# PLANNING & ZONING

**Planning and Zoning Commission -  
Plat Agenda**

**WRITTEN STATEMENT OF REASONS  
FOR CONDITIONAL APPROVAL OF A PLAT APPLICATION**

**Re:** Marrowbone Spring Park Addition, Final Plat

**LOCATION MAP**  
**SOL DAVIS ADDITION, LOT 73R**  
**PRELIMINARY PLAT**

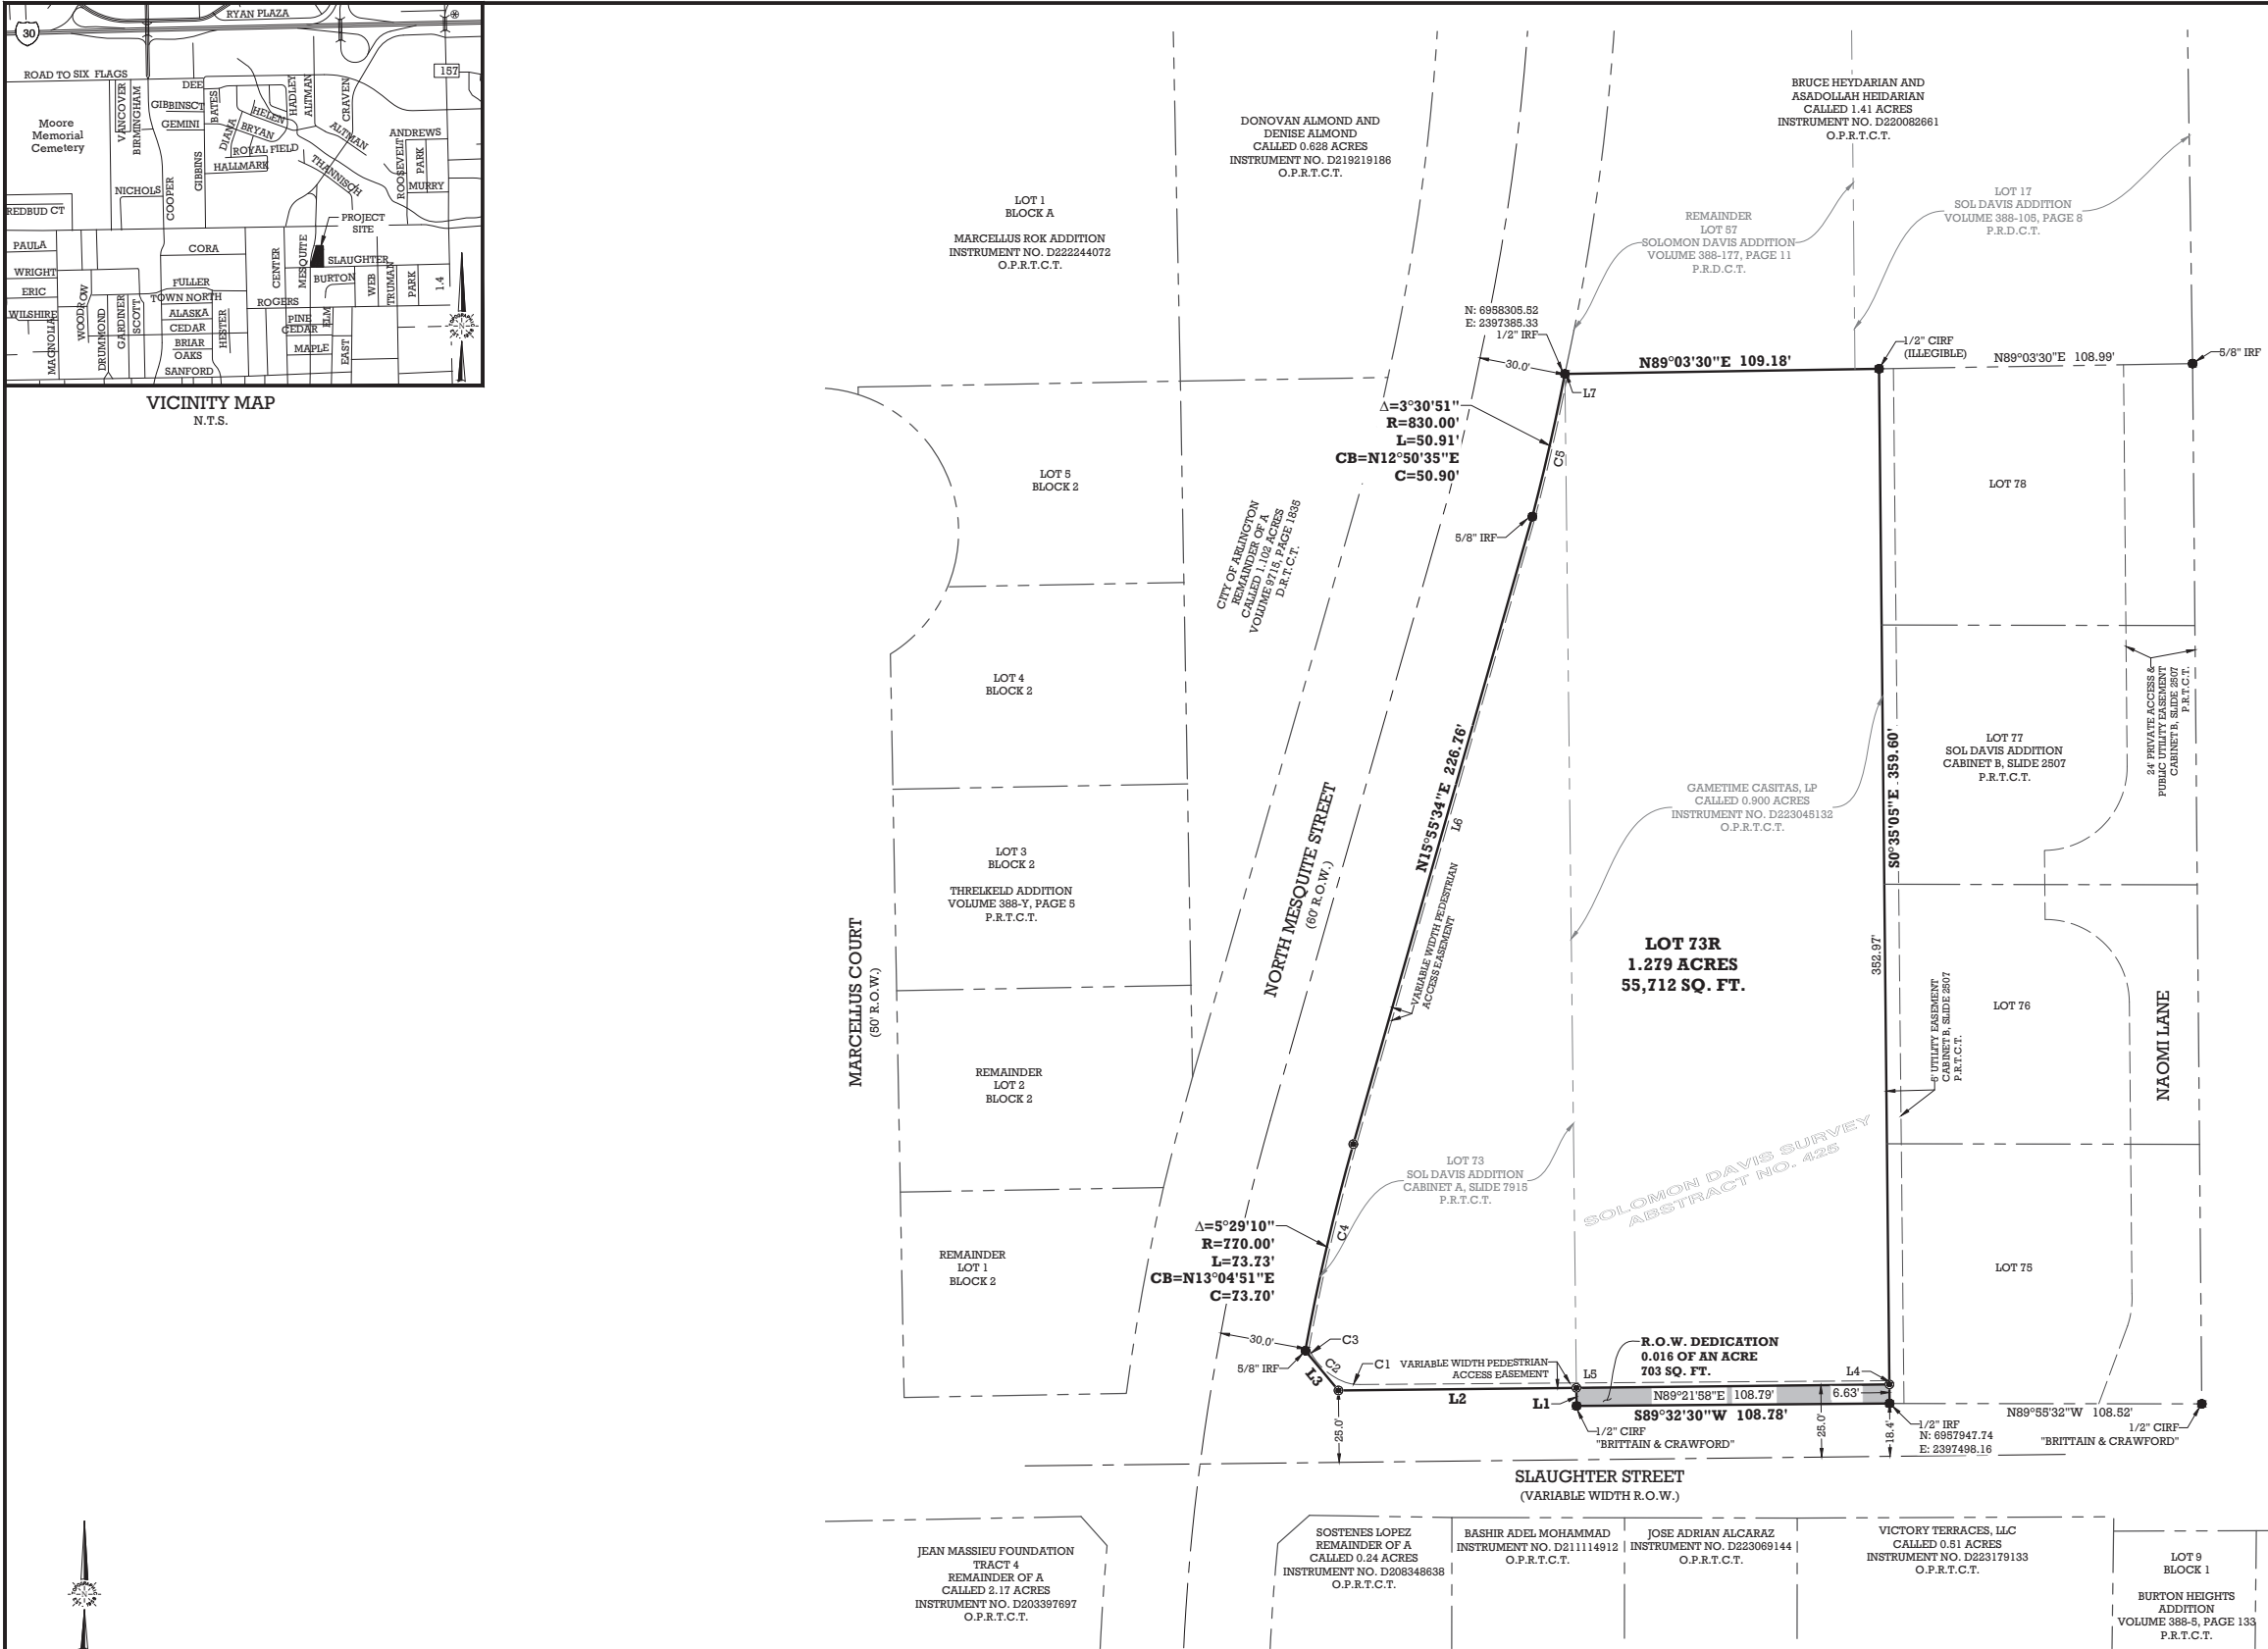
3. The legal description and drawing shall agree. Include the legal description on the face of the plat. (Standard Plat Formatting)
4. The Filing Information should read as follows:  
This plat is recorded in instrument number \_\_\_\_\_, dated \_\_\_\_\_  
(Standard Plat Filing and Formatting)

- c) This plat does not alter or remove deed restrictions or covenants.
  - d) A note describing the reason for amendment (i.e., to cure an encroachment, provide for a more buildable area, to correct an error, etc.) shall be included in the general notes on the plat. (Standard Plat Filing and Formatting)

6. The location of all existing or proposed fire lanes and fire hydrants needs to be shown on the plan documents.
7. (Informational): Fire lanes and access will need to meet the design requirements of our Design Criteria Manual at the time of development. If shared access between lots will be needed, an agreement will need to be put in place. Fire lane/access per section 4.5.6 within the DCM. (Contact COA Engineering for process).
8. The location of all existing or proposed fire lanes and fire hydrants needs to be shown on the plan documents.
9. The construction type/square footage of the structure needs to be provided. Section 503 of 2021 International Fire Code

10. The radii for all turns along the fire lane need to be indicated on the plan documents, the minimum inside turning radius is 30 feet with a 54 foot outside radius. | Fire Department Ordinance, Section 503.2.4

11. All buildings or structures shall be constructed such that all ground level, exterior sides of the building are within 150 feet of a dedicated street or fire lane, as shown in Figure 4-3, Hose Lay. The 150 feet is measured along the route necessary to extend fire hose lines around the building (as measured 10 feet off the building). If the 150 feet cannot be reached from a public street, a fire lane will be required on site. DCM 4.5.6, A

17. Provide a preliminary storm water management site plan showing the post construction BMPs to be used onsite. (DCM 5.10)
18. The detention pond must be contained within a public drainage easement. (DCM 2.1.2)

19. The post development plan shows detention being needed for the site, but the detention basin is not shown in the site plan. Show the detention area and provide preliminary information such as size, rate of discharge and where will it drain to. The runoff must be carried to an adequate and acceptable outfall. (DCM 5.9)

21. The grading plan shows the ground being raised. This can create conflicts with the adjacent properties with the proposed buildings being so close to the property line. Show how the grading will transition to the existing grade at the property line. The proposed development cannot cause any adverse impacts to the adjacent properties. (DCM 5.3)

24. Show the applicable visibility triangles at the street intersection and the driveways. No obstructions, including fences, signs or structures can be located within the visibility triangle area. (DCM 4.5.2)

25. Show the distance from the driveway to the intersections. The distance and driveway dimensions must meet the DCM Table 4-9. (DCM 4.9)
26. The site layout should be based on the ultimate property line locations after the right of way dedications. (DCM 4.2)

28. Include the following note to the face of the plat (DCM 5.3):  
"The City of Arlington reserves the right to require minimum finish floor elevations on any lot contained within this addition. The minimum finish floor elevations shown are based on the most current information available at the time the plat is filed and may be subject to change."

33. The plat shall include GPS coordinates for the Point of Beginning in U.S. feet, State Plane GRID Coordinate System (NAD83) - Texas North Central Zone (4202). Provide scale factor if applicable.
34. Show the written deed description on the plat document.
